SERVICE BULLETIN

Model: 30RESA and 30REYG

Subject: Air Intake Resonator Kit GM75873 for LP-Fueled Generator Sets

Figure 1 Air Intake Resonator Kit, Installed

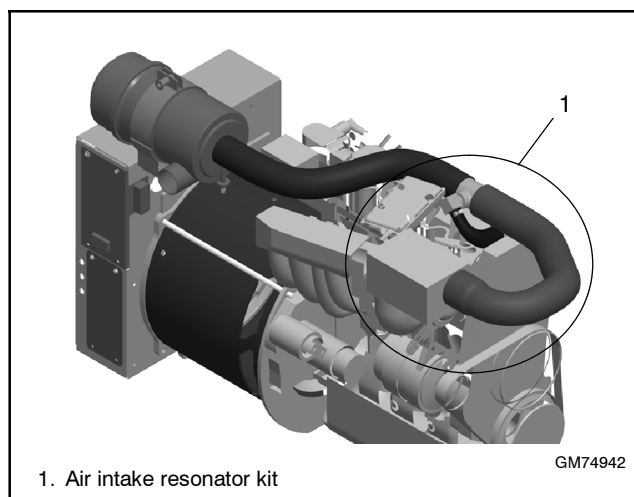
Kohler has determined that some Model 30RESA and 30REYG generator sets with specification numbers starting with GM69190 may experience hard starting when operated on LP fuel. An air intake resonator and revised engine ECM software have been released to resolve this issue.

Refer to TT-1549 for instructions to install the air intake resonator service kit and reprogram the engine ECM. TT-1549 is provided with service kit GM75873. See Figure 1 for an illustration of the installed kit.

For units installed and operating on LP fuel, install the service kit and ECM software update at your earliest convenience. If the air cleaner was modified prior to the availability of this kit, please install a replacement air cleaner assembly GM36199 during the kit installation. For units currently not in service, install the kit and update the ECM software either during the startup inspection or prior to the unit being received by the owner.
